SITE SERVICING STUDY & STORMWATER MANAGEMENT REPORT

1386-1394 GREELY LANE
OTTAWA, ONTARIO

REPORT NO. 24015

JANUARY 13, 2025
REVISED MARCH 6, 2025
REVISED MARCH 24, 2025
REVISED JULY 30, 2025
REVISED SEPTEMBER 29, 2025
REVISED NOVEMBER 20, 2025

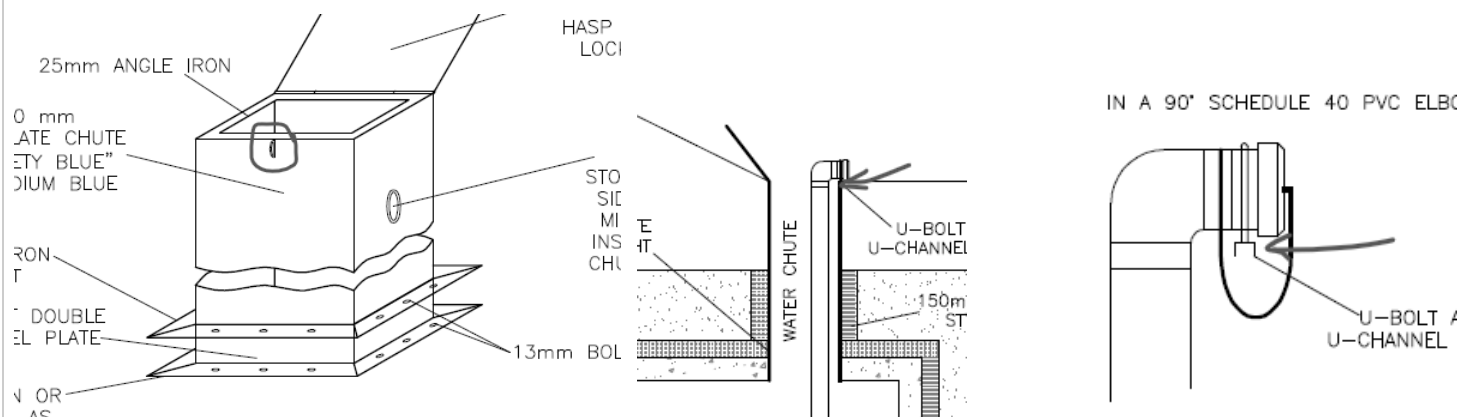
Apologies, I don't mean to keep adding observations with each change, but I also don't want there to be misunderstandings that will get missed and become bigger problems later on.

I assume the chute on the other tanks are just for access (and/or vent)? Correct. To be clearer the access opening are now labelled: "ACCESS OPENINGS WITH VENTS (NO DRAW PIPES)" and the water chute is labelled as "WATER CHUTE WITH DRAW PIPE". They aren't required to be chutes, but I leave it up to you to decide – just be sure these non-fire use ones are NOT painted blue – blue is an indicator of "draft" for Ottawa Fire Services so only the one we are drafting from with a chute should be blue. Our details on drawing C-8 have been revised. The 'Water Fill Station' detail now has the follow note: "ONLY ONE TANK SHALL HAVE A DRAW PIPE (AS INDICATED ON PLANS). TANKS WITHOUT A DRAW PIPE SHALL HAVE AN ACCESS OPENING WITH A 150 mm "CANDY CANE" VENT C/W WITH RODENT SCREEN. THE ACCESS OPENINGS SHALL NOT BE PAINTED BLUE." Also worth noting that depending on the size of the interconnecting pipes between tanks, an anti-vortex plate may be required – I'll leave it to your engineering judgement on these. The interconnecting pipes are 250mm in diameter. At 4500 L/min the velocity is only 1.5 m/s so an anti-vortex plates should not be required. I would be more concerned with the 150mm draw pipe, which at 4500 L/min, the velocity is 4.2 m/s. The bottom of the draw pipe used to be cut on an angle but, especially now that the bottom is 'cut square', I would expect that vortexing could be an issue. Have you experienced vortexing with a 'cut square' draw pipe?

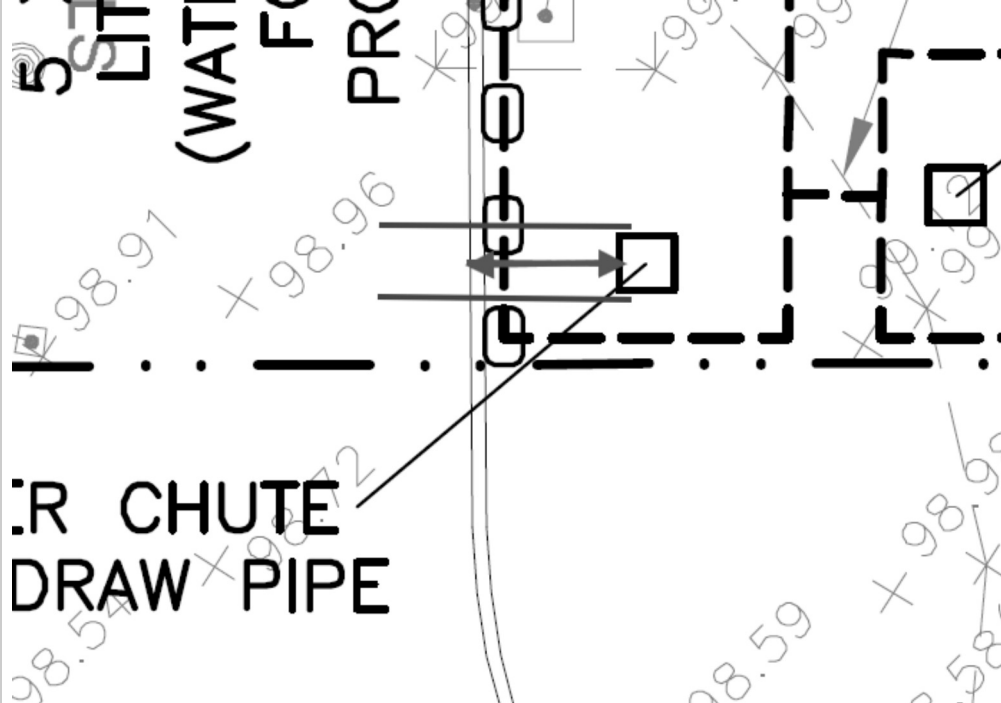
I also wanted to draw the attention to something I've mentioned in meetings past (I think with you, but possibly not). Be sure that the padlock hole doesn't interfere with the u-channel on the draft pipe since it rests on the ledge of the box. Typically this is done by extending the hasp and lowering the eye for the lock. The following note is now on our 'Water Chute' detail: "THE STAPLE SHALL NOT INTERFERE WITH THE U-CHANNEL ON THE DRAW PIPE."

I noticed there isn't a specification for the distance from the curb to the closest edge of the draft chute (bottom picture red arrow line). This dimension is important since we are using a fixed length of hard suction (3m) to connect. The connection port on the fire truck is often slightly inset of the outer edge of the truck (ie: further away) so the distance curb to close-edge of chute should be in the 1.5-1.8m distance (we can tolerate up to about 2m). We have added a dimension on drawing C-1 (± 1.6 m MAX. 1.8m). We have also added the following note on the 'Water Fill Station' detail: "THE FRONT FACE OF WATER CHUTE SHALL BE LOCATED A MAXIMUM 1.8m FROM FIRE ROUTE". On the 'Water Fill Station' detail we specify 'Boyd Bros Concrete or Approved equal' because they make a 45,000 L tank that is about 2.7m wide. Other tanks are 3.05m (10 ft) which may make it difficult to achieve the maximum 1.8 m (or up to 2.0 m) and keep the tank at least 0.5m from the edge of the asphalt.

And finally on a related note I see that you are using armour stone to also help protect the draw chute. In general that's fine, but please be sure that the height of the armour stone will not interfere with the suction hose (it is very inflexible). It may be advisable to leave a gap between the stones directly in front of the draft box at least the width of the box wide (blue lines). The following note has been added to C-1: "THERE SHALL BE NO ARMOUR STONES DIRECTLY IN FRONT OF WATER CHUTE".

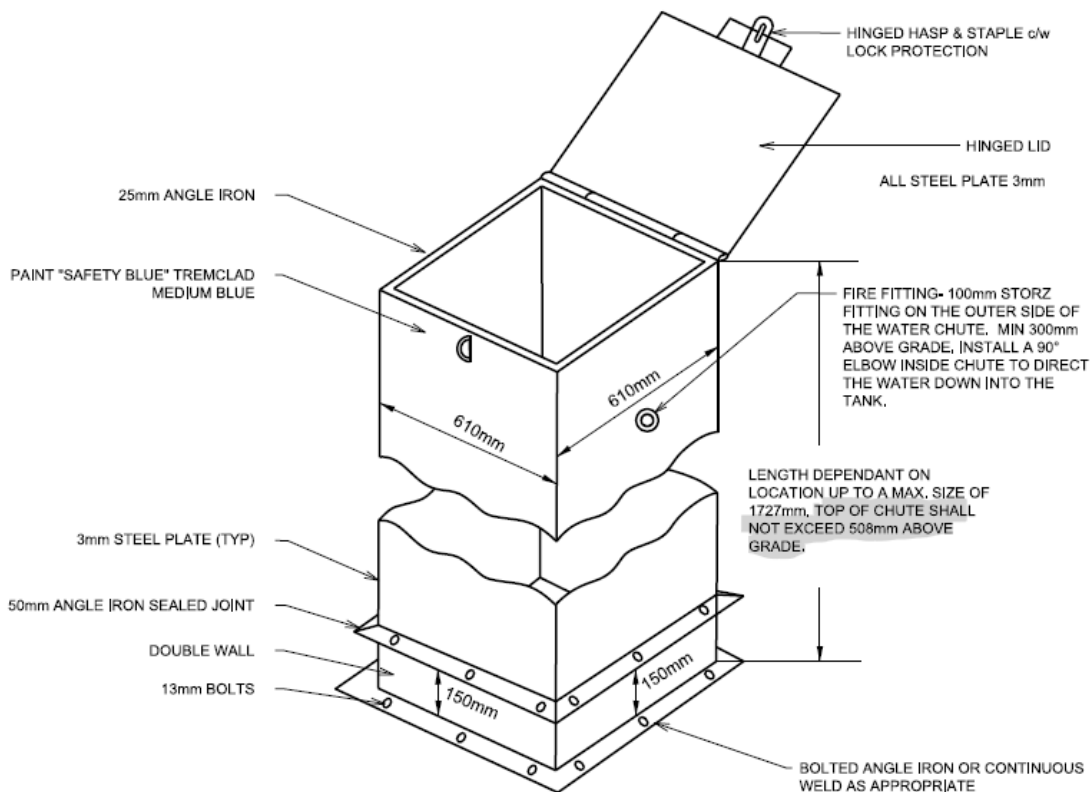
Qbuild = 225 000 L (ensure these tanks are 45000 L and not a 10000 US Gal (37 850 L))

Since FF > 4500 L/min, no reduction in Q is permitted

Qbuild > Qcalc -> therefore acceptable

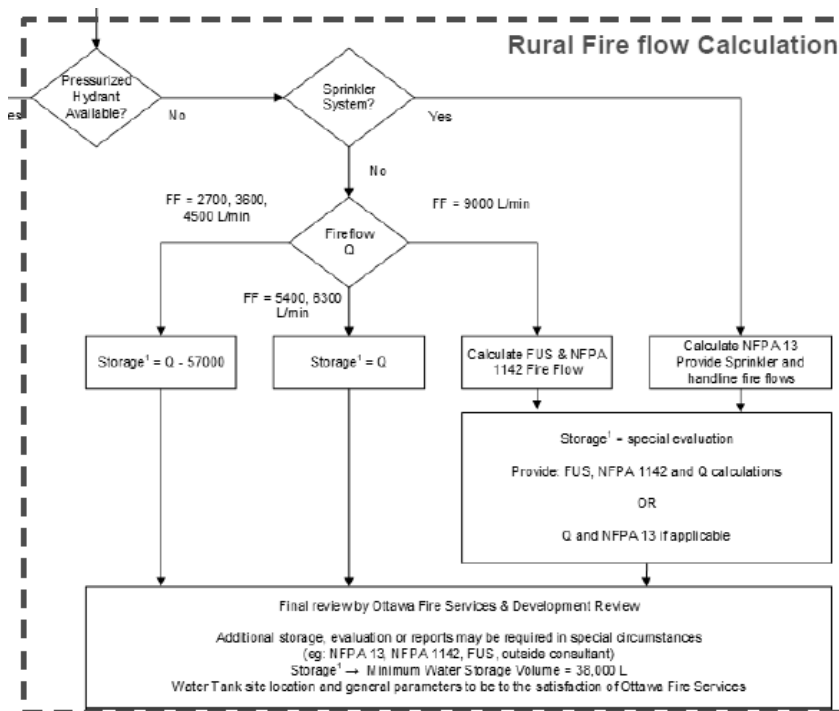
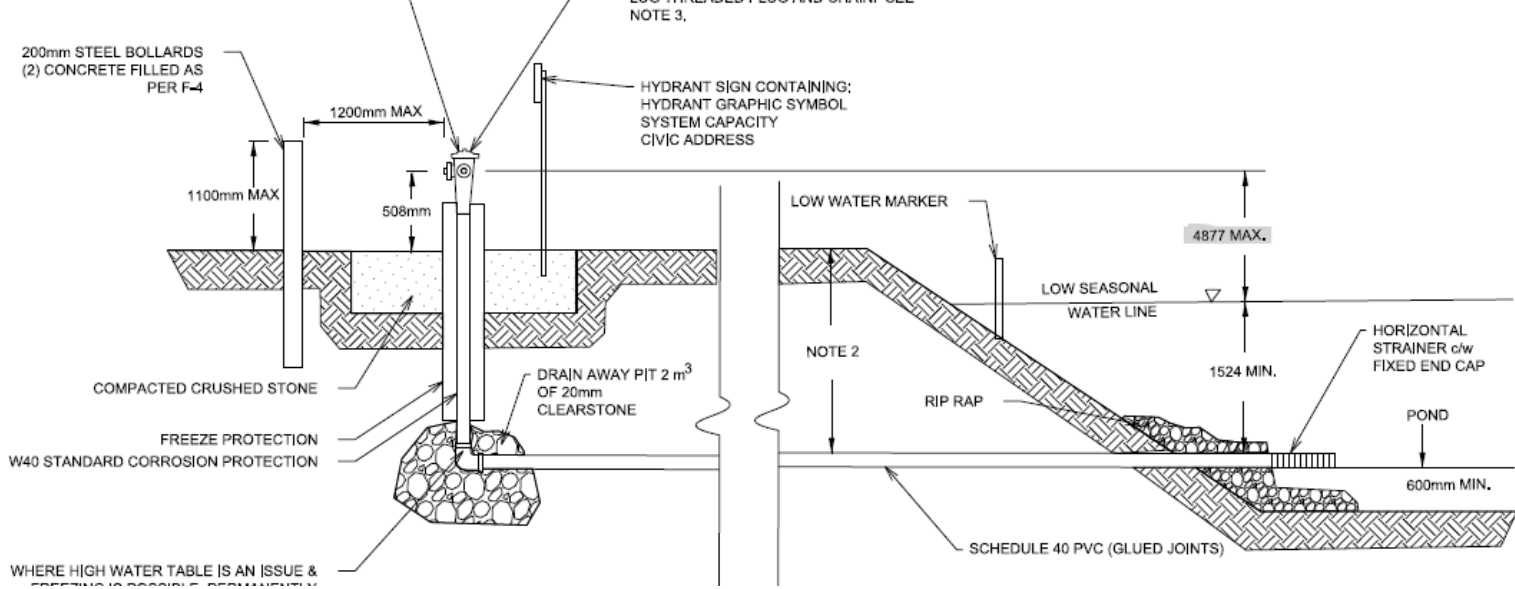
Damien reminded me that the W51 spec has some specs that are out of date (my best guess is they were specified back when there were limited tanks available).

The specifications I wanted to highlight are:

- maximum draft height (lip of chute to bottom of tank) 4877mm (16 feet) (I used the value from the pond/river draft (bottom drawing)
- Top of chute above grade should be between 610 mm (24") – 813 mm (32") (**disregard** the 508mm maximum in drawing)

- there is some minor flexibility on the upper number but I wanted to provide a target range. The goal is to make sure it is not easily covered in winter (not too low), safe (too low leads to risk of falling in) and comfortable to lift the pipe inside out (not too high)
